20 September 2018

Mark Pisani
Traffic Engineer
City of Yarra

**Proposed Mixed Use Development
622-642 Nicholson Street, Fitzroy North**

Figure 5.1: Overall Traffic Volumes

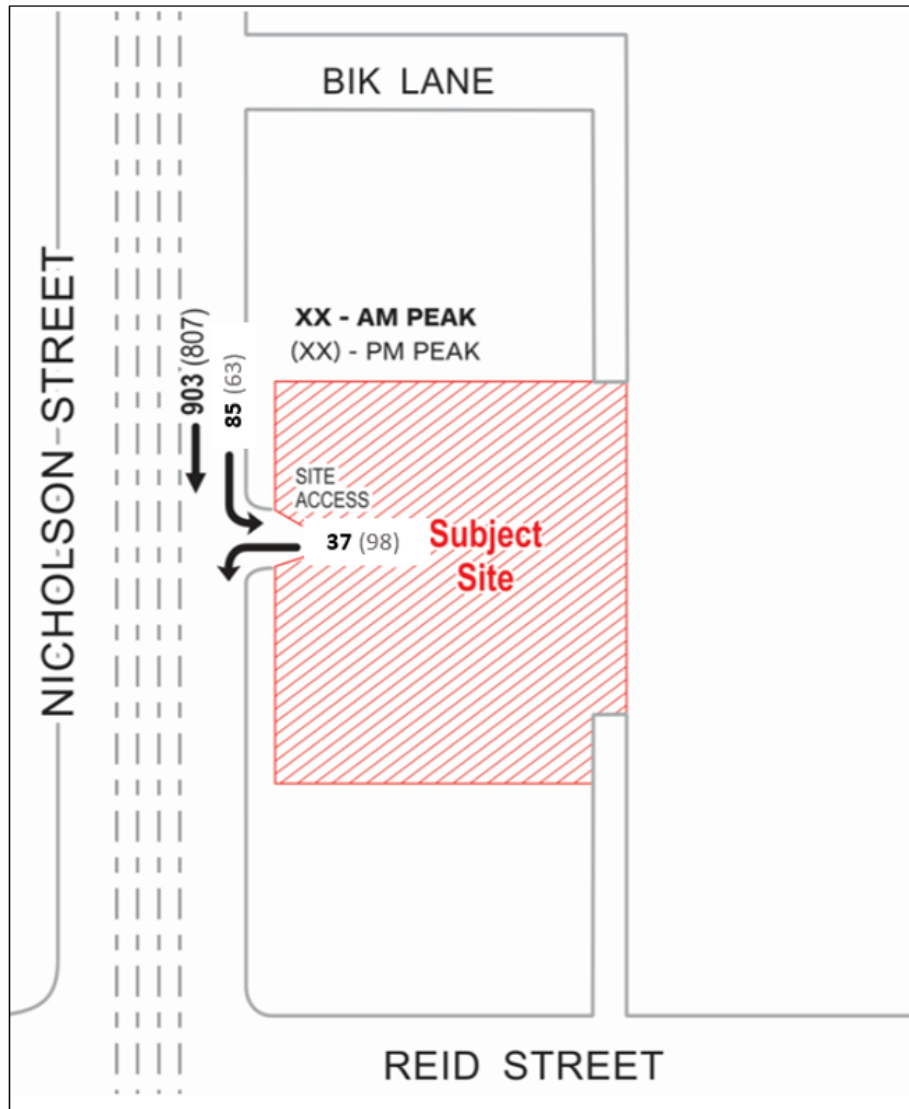
The submitted report does not provide information on the impact the development traffic would have on the operation of Nicholson Street. Can the development traffic be absorbed by Nicholson Street during the AM and PM peak hours? Further information on this matter should be forwarded to Council.

Figure 5.1 shows the overall traffic volumes (site generated traffic and existing volumes) at the Nicholson Street access point during the AM and PM peak hours.

To assess the impact of the development traffic on Nicholson Street, a SIDRA analysis has been undertaken at the proposed vehicle access point along Nicholson Street during the AM and PM peak hours.

- The vehicle access point will operate under 'Excellent' conditions in both the AM (0.272 DOS) and PM peak hour periods (0.239 DOS);
- Vehicles are able to depart the site onto Nicholson Street with minimal queues and delays in both the AM and PM peak hours; and
- Traffic entering and exiting the site will have minimal impact on through traffic along Nicholson Street.

On the basis of the above analysis, it is concluded that the level of traffic generated by the proposal can suitably be accommodated by Nicholson Street. This is expected given that the site access is limited to left-in, left-out movements.

Figure 7.1: Proposed Tram Stop Upgrade Sections

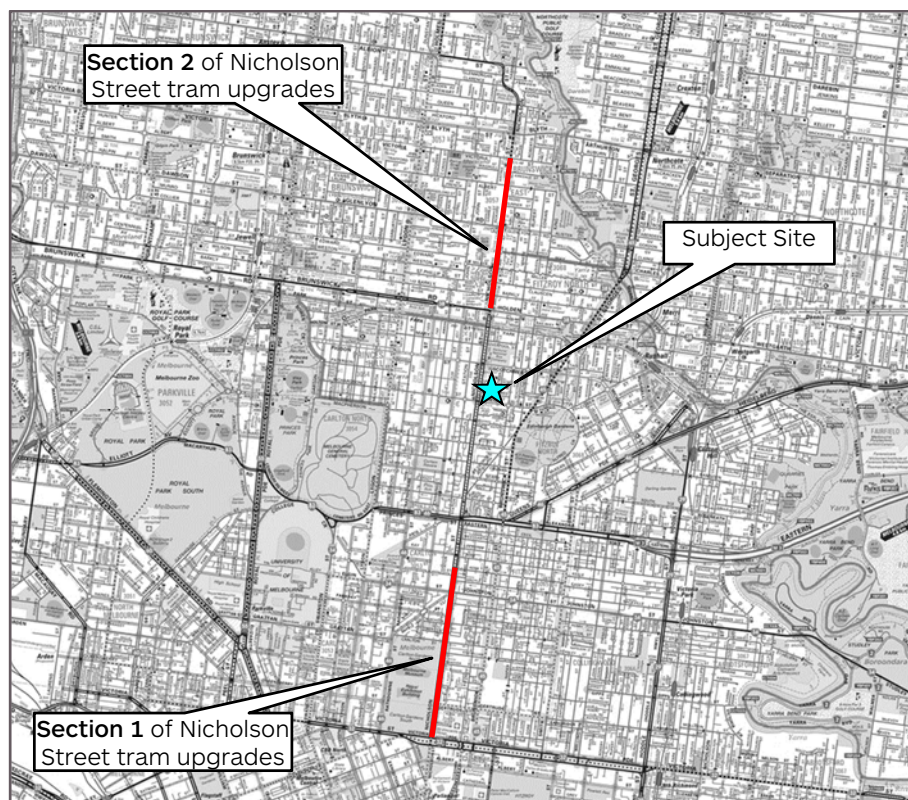
Separate to the traffic analysis discussed above, it was noted within Council's strategic transport comments that tram stops along the length of Nicholson Street are proposed to be upgraded for DDA compliance.

Tram Stop 20 is located directly fronting the subject site on Nicholson Street and based on information provided from PTV is not currently planned to be upgraded. In relation to future upgrades of the remaining tram stops along Nicholson Street, PTV notes the following:

It is considered unlikely that any proposed upgrade works to Tram Stop 20 would adversely impact vehicle access to the subject site, particularly given that vehicle access is already limited to left-in, left-out vehicle movements along Nicholson Street.
